**From:** Habib, Donald  
**Sent:** Tuesday, July 03, 2012 5:00 PM  
**To:** Snyder, Amy  
**Subject:** Public Documents for Levy 7/5 Public Call (1 of 3)  
**Attachments:** FSAR Section 2.5.4 Text and Figure Revisions - Grouting ML12184A141.pdf; Levy Ltr 108 Response for FukuRecom9.3 6-21-12 ML12173A286.pdf; CEUS SSC Evaluation Process - Option A 07 02 12 ML12185A116.pdf; NRC Letter 108 RAI L-0998 Response - Draft 07-02-12\_Part3 ML12185A109.pdf; NRC Letter 108 RAI L-0998 Response - Draft 07-02-12\_Part1 ML12185A071.pdf

#### 2.5.4.5.1.2 Permeation Grouting

# OPTION A: EVALUATION OF CEUS SSC SEISMIC HAZARDS AT LNP SITE

## Revised FSAR Figures

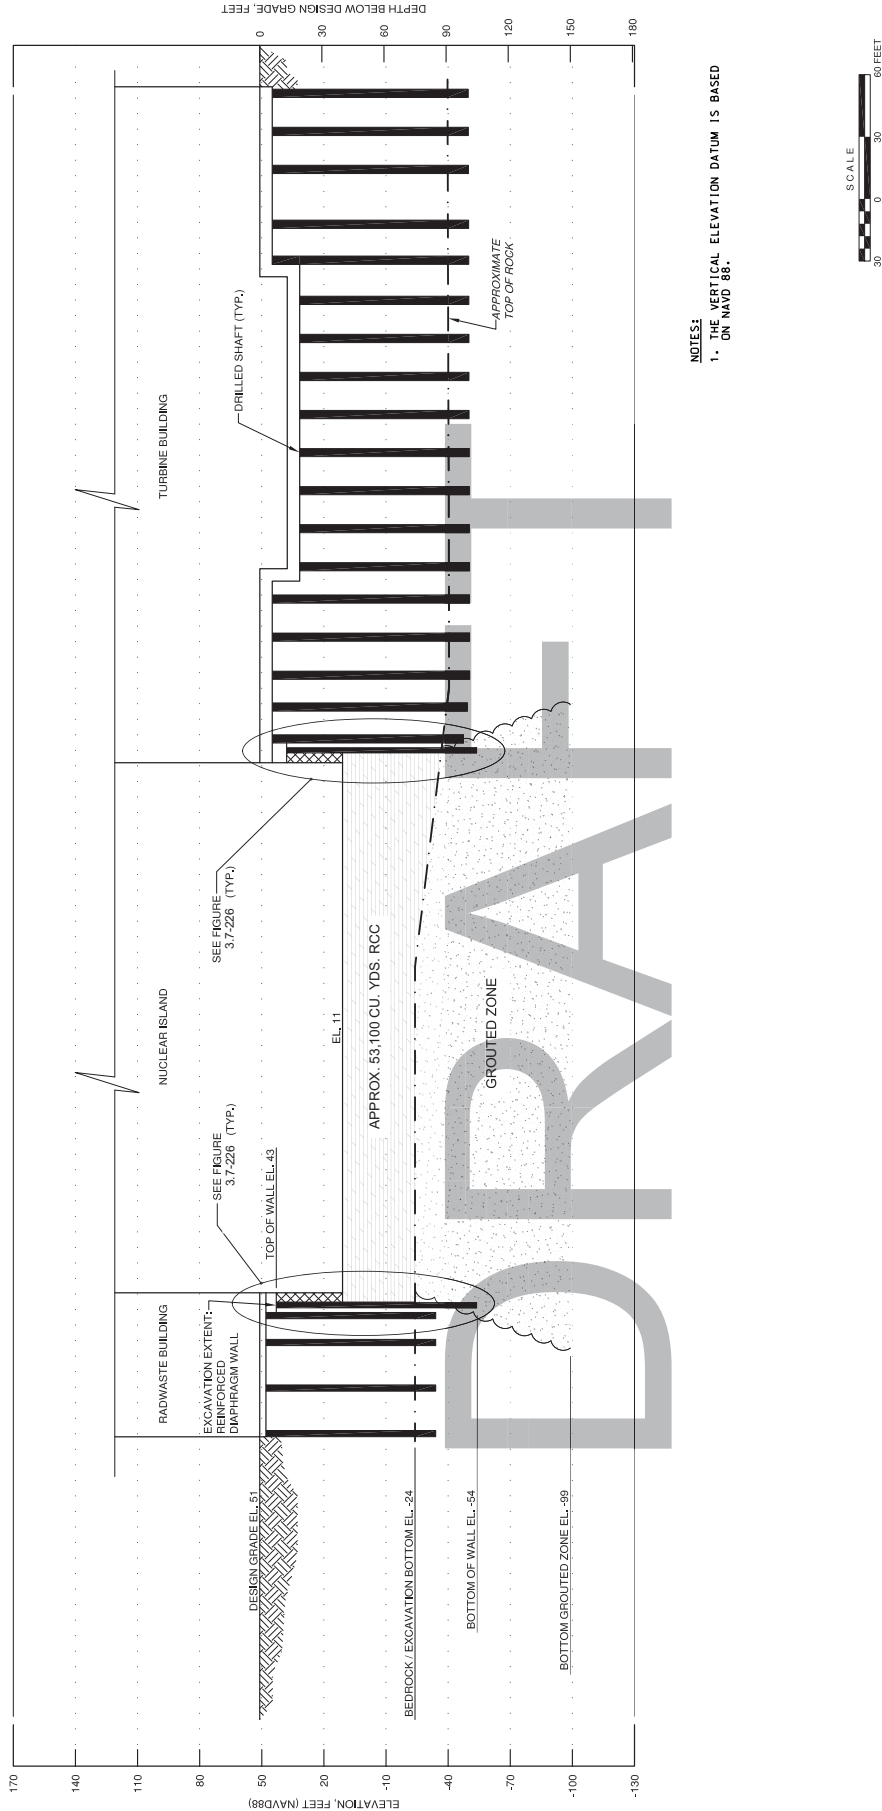
Grouting will generally be performed by the upstage method with pneumatic packers and a suite of grout mixes that range in viscosities from 35 seconds to over 80 seconds. Primary grout holes will be spaced on a 4.8 m (16 ft.) hexagonal pattern, and split spaced with secondary grout holes to achieve “no take” conditions.

Provisions will be in place to perform additional split-spacing to tertiary grout holes, as dictated by the performance of the production grouting. Effective grouting pressures will be limited to approximately 0.5 psi/ft of depth, monitored using a GIN curve and penetrability curve developed during the Grout Test Program (discussed in FSAR Subsection 2.5.4.5.1.2.2). Hole spacing, grouting pressures, and acceptable grout takes will be established with the grout program. The target residual conductivity of the production grouting will be 15 Lugeons. Grouting is nonsafety-related, however it will be performed under a quality program.

**Deleted:** The grouting operation will be conducted from, at or near, the existing ground surface by drilling boreholes from the surface down to the approximate elevation of -30.2 m (-99 ft.) NAVD88, and setting casing (either perforated or “tube-a-manchette” – a rubber sleeve between two packers). While uncased holes would be preferred, the existing site characterization data suggest that the holes may cave before they can be grouted; therefore, casing will be specified. The top elevation of the grouted zone will be at elevation -7.3 m (-24 ft.) NAVD88, resulting in a 22.9 m (75 ft.) thick grouted zone.¶

¶ Grouting will generally be performed by the upstage method with pneumatic packers and a combination of lower mobility grout (LMG) and high mobility grout (HMG) to be established with a Grout Test Program prior to the commencement of the grouting program, as discussed in FSAR Subsection 2.5.4.5.1.2.2. Grout holes are initially spaced to achieve “no take” conditions. Hole spacing, grouting pressures, and acceptable grout takes will be established with the Grout Test Program. Grouting is non safety-related, however it will be performed under a quality program.¶

LNP 2 Postulated Liquefaction Pockets (Section)  
For 10<sup>-5</sup> UHRS  
Figure 2.5.4.8-210

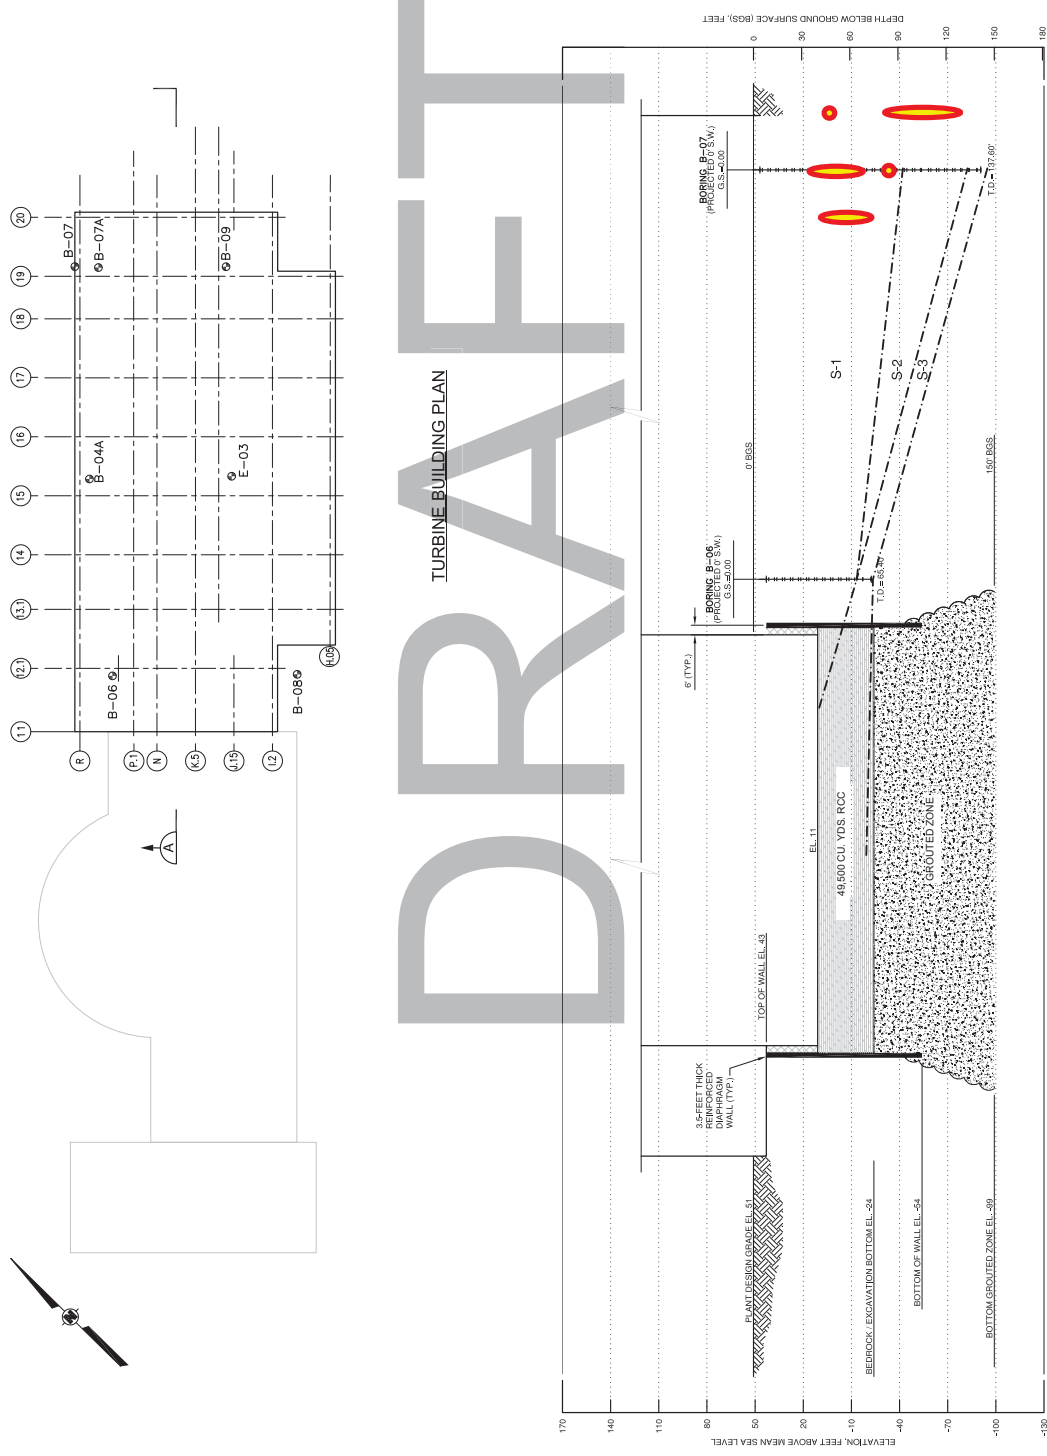
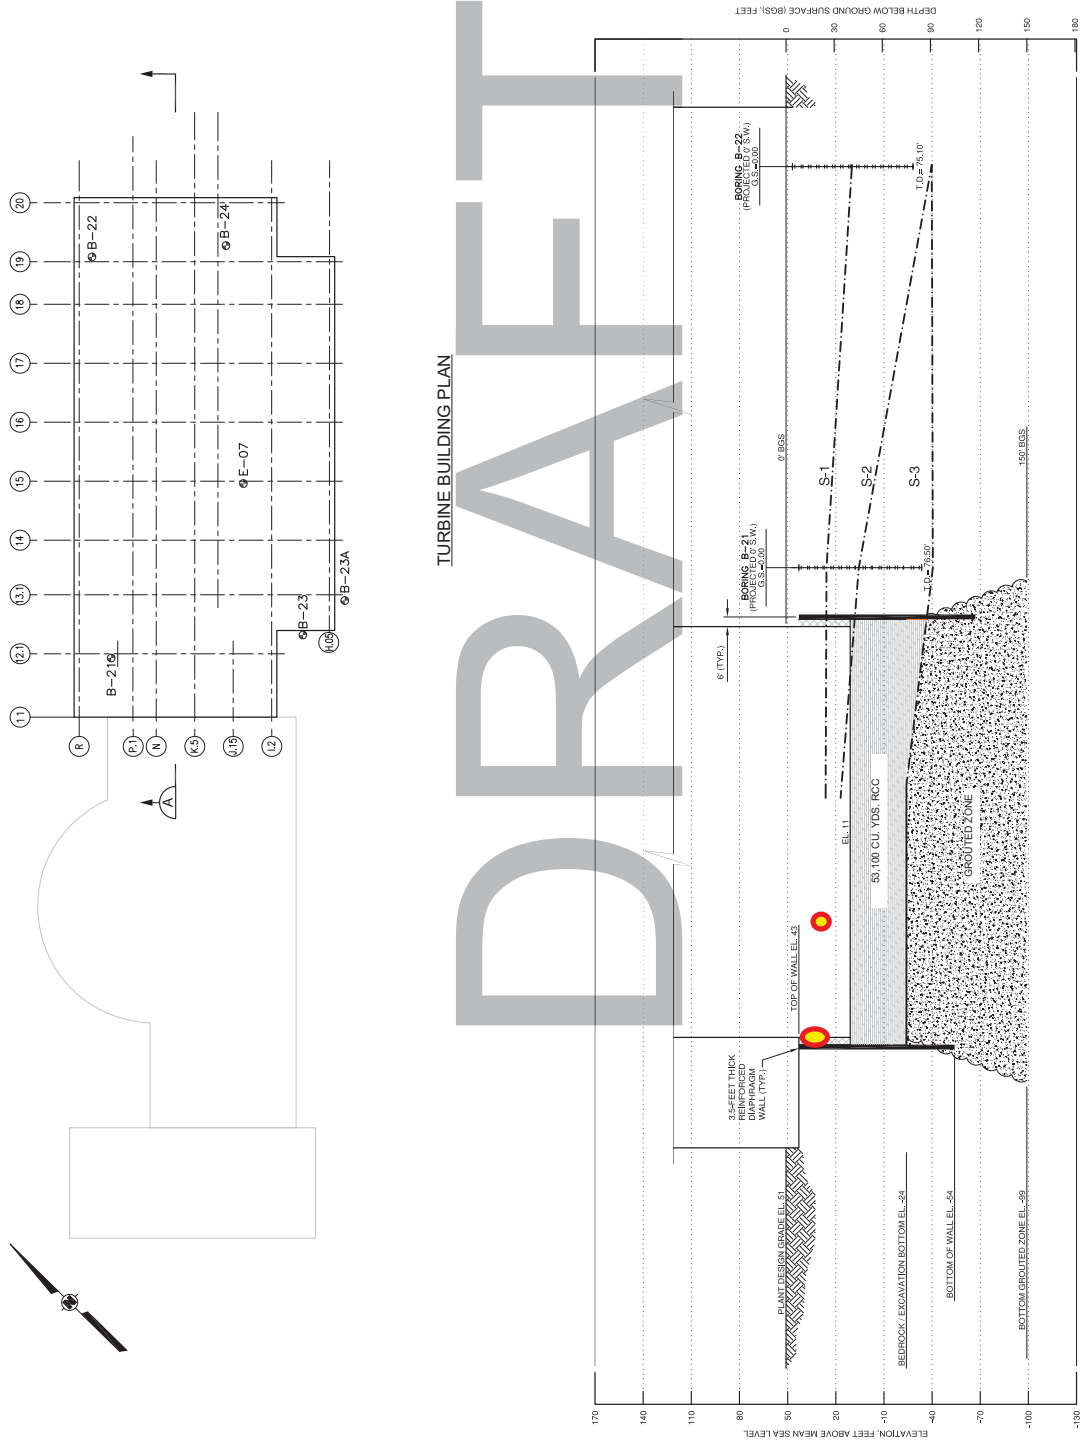
To evaluate the HCLPF liquefaction potential of soils under the adjacent AB, TB, and RB, earthquake induced cyclic stresses in the soil column based on ground motions consistent with the updated EPRI SOG finished grade  $10^{-5}$  UHRS were used. As shown in Figures 3.7-228 and 3.7-229,  $1.67^*GMRS$  and  $1.67^*PBSRS$  developed using the CEUS SSC methodology and modified CAV filter are enveloped by the updated EPRI SOG finished grade  $10^{-5}$  UHRS. Thus, HCLPF capacity for no liquefaction potential of soil under the AB, TB, and RB exceeds the  $1.67^*GMRS$  goal for the plant level HCLPF for the CEUS SSC ground motions.

Figure 2.5.2-357 Comparison of PBSRS based on updated EPRI-SOG and CEUS SSC models

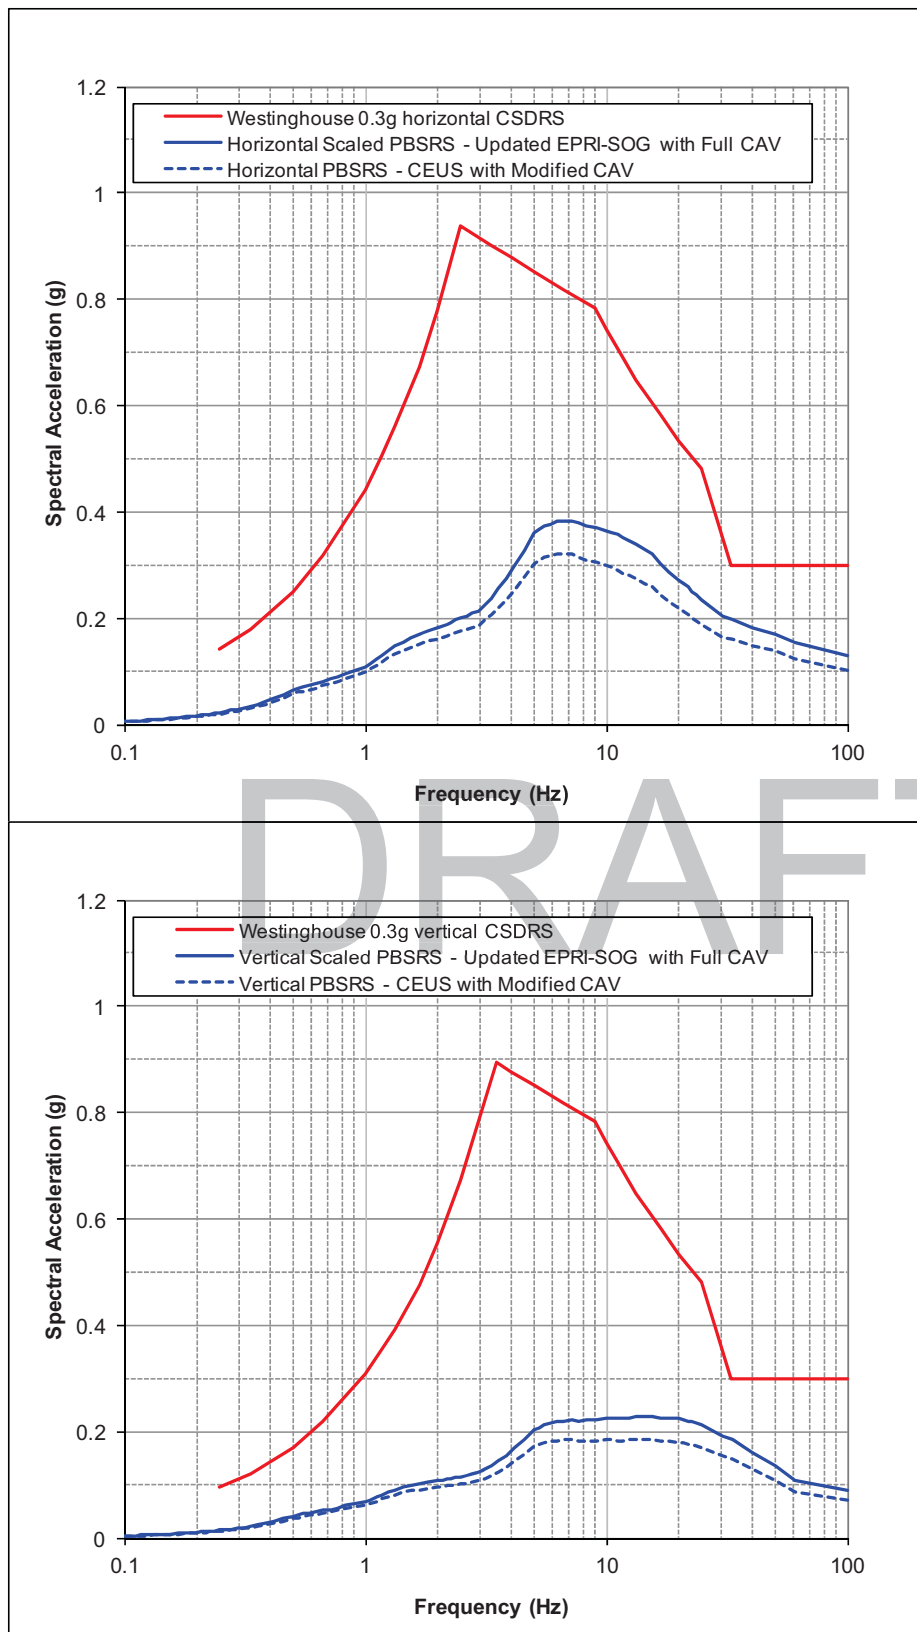
As shown in Figure 2.5.2-357, the CEUS SSC PBSRS is enveloped by the updated EPRI SOG scaled PBSRS used for site specific displacement of the Annex Building, Turbine Building, and the Radwaste Building as described in Subsections 3.7.2.8.1, 3.7.2.8.2, and 3.7.2.8.3. Thus the conclusions in these subsections of no seismic interaction between the Annex Building, Turbine Building, and Radwaste Building and the NI is valid for the LNP site ground motions based on the CEUS SSC model.

Figure 2.5.2-357 compares the PBSRS based on the CEUS SSC model with modified CAV to the scaled PBSRS based on the updated EPRI-SOG model with full CAV. The percent differences between the two sets of GMRS are given in Table 2.5.2-235. The PBSRS based on the CEUS SSC model with modified CAV is enveloped by the PBSRS based on the updated EPRI-SOG model with full CAV. Both sets of PBSRS are well enveloped by the Westinghouse AP1000 CSDRS.

**Figure 2.5.2-358:** Comparison of Reactor Building FIRS based on updated EPRI-SOG and CEUS SSC models

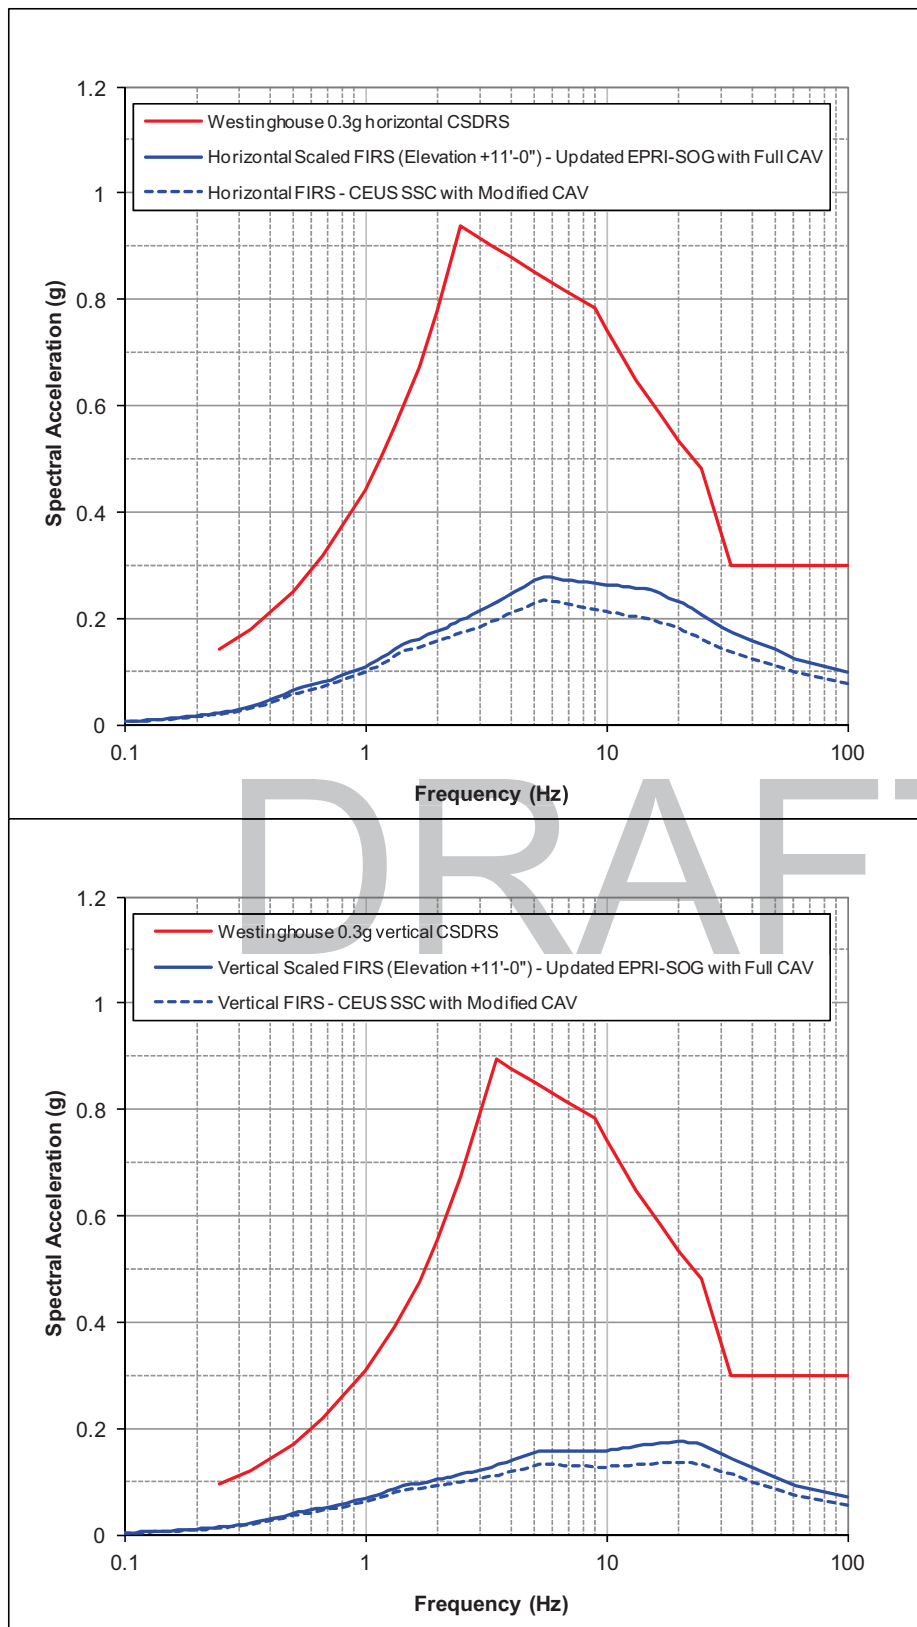
As shown in Figure 2.5.2-358, the CEUS SSC horizontal and vertical FIRS is enveloped by the updated EPRI SOG scaled horizontal and vertical FIRS used for site specific soil structure interaction analysis described in Subsection 3.7.2.4.1. Thus, the conclusions of the soil structure analysis presented in Subsections 3.7.2.4.1.5 and 3.7.2.4.1.6 are valid for the LNP site ground motions based on the CEUS SSC model.

PBSRS elevation computed using the CEUS SSC model with modified CAV divided by the UHRS amplitudes computed using the updated EPRI-SOG UHRS without CAV. Figure 2.5.2-358 compares the FIRS based on the CEUS SSC model with modified CAV to the scaled FIRS based on the updated EPRI-SOG model with full CAV. The FIRS based on the CEUS SSC model with modified CAV are enveloped by the scaled FIRS based on the updated EPRI-SOG model with full CAV.

Figure 3.7-228

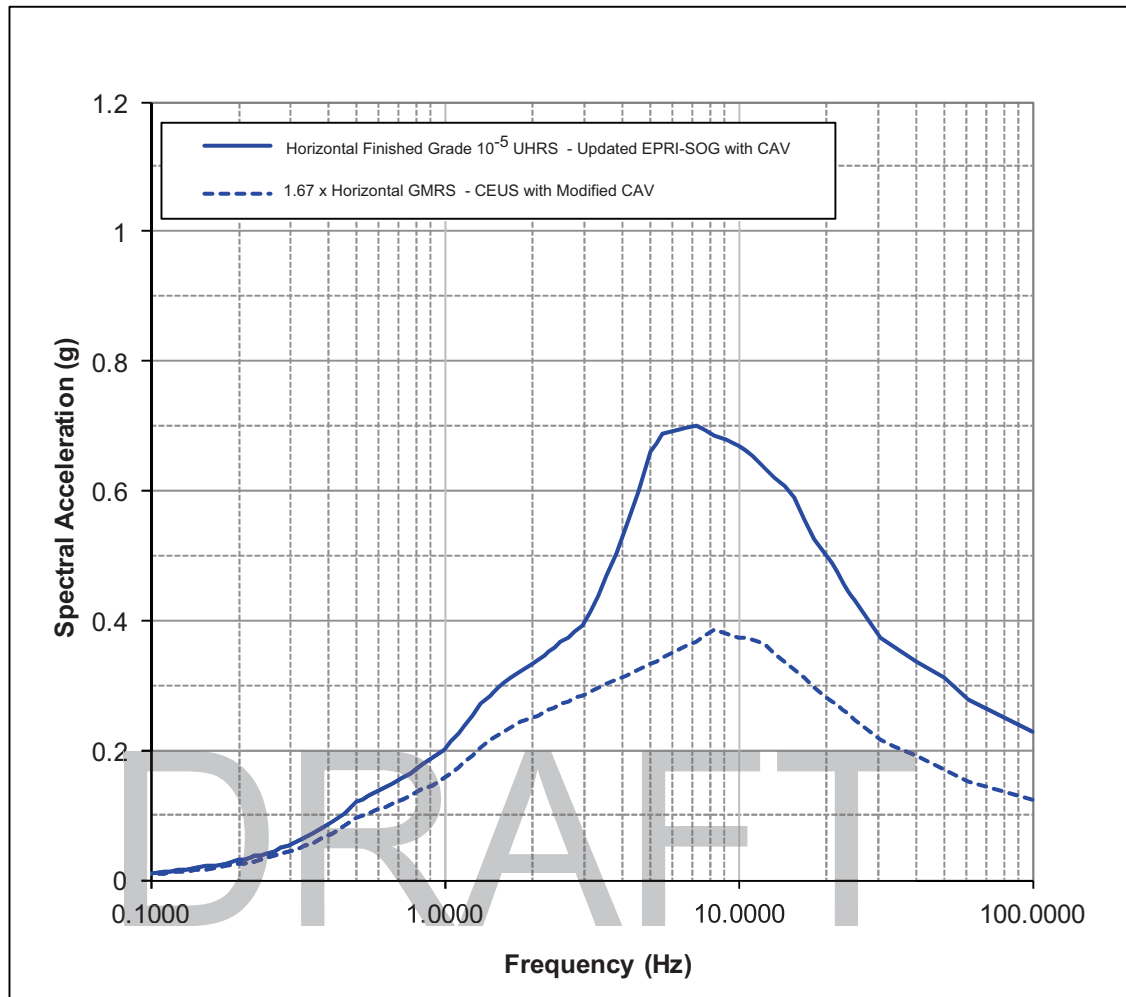
Comparison of the horizontal 10<sup>-5</sup> UHRS using the Updated EPRI-SOG model with 1.67 x the GMRS using the CEUS SSC model with modified CAV
